# CASE NO: Z2004270

## Staff and Zoning Commission Recommendation - City Council

**Proposal:** To relocate computer networking company

**Subject:** Zoning Case Z2004270 (Redland Road Computer Offices)

Zoning Case Z2004270 Figure 2

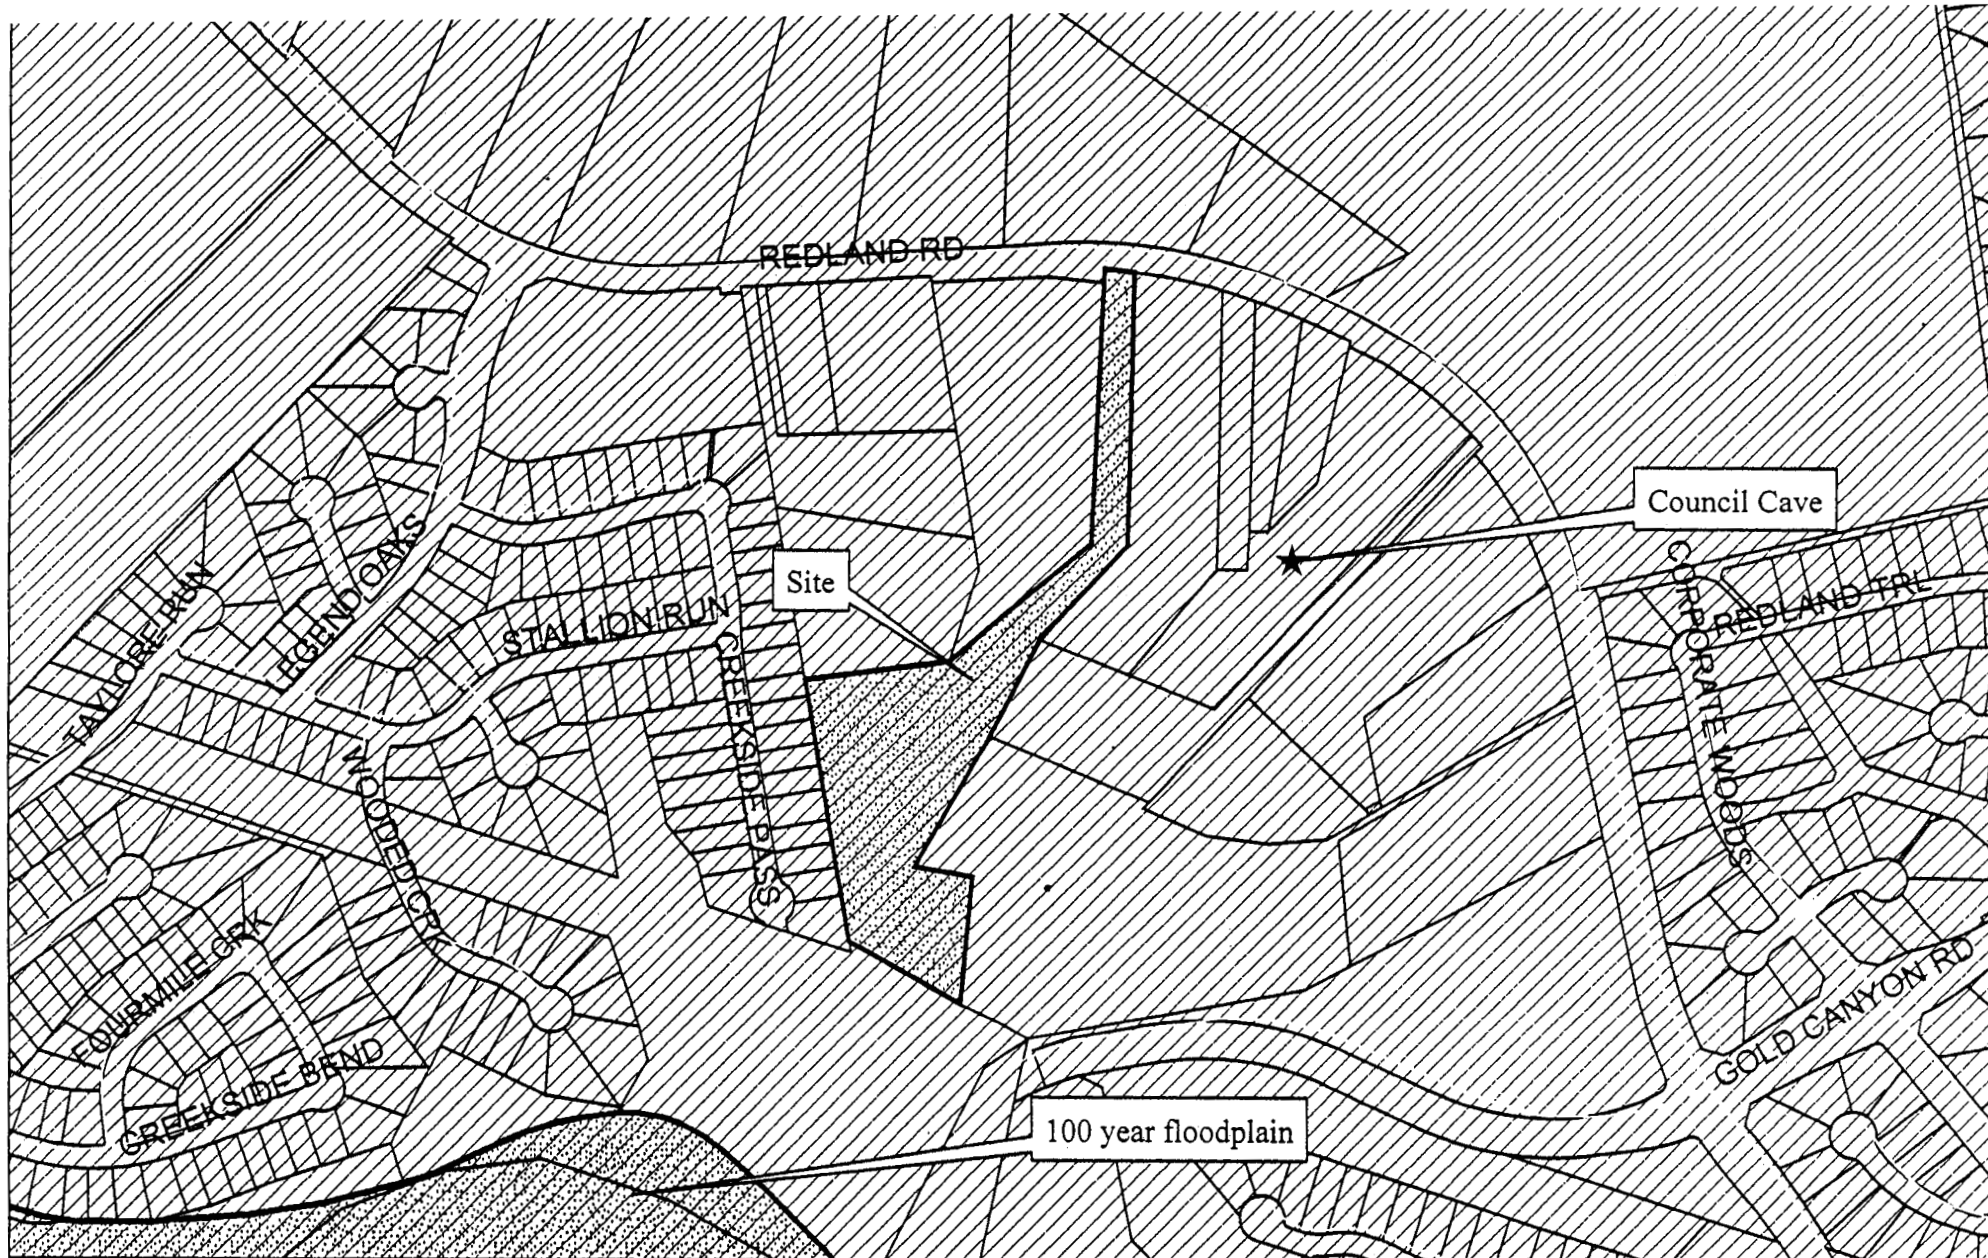
The subject property is located in City Council District 9, along the south side of Redland Road, north of Gold Canyon. The property is within the Edwards Aquifer Recharge Zone (Figures 1 and 2).
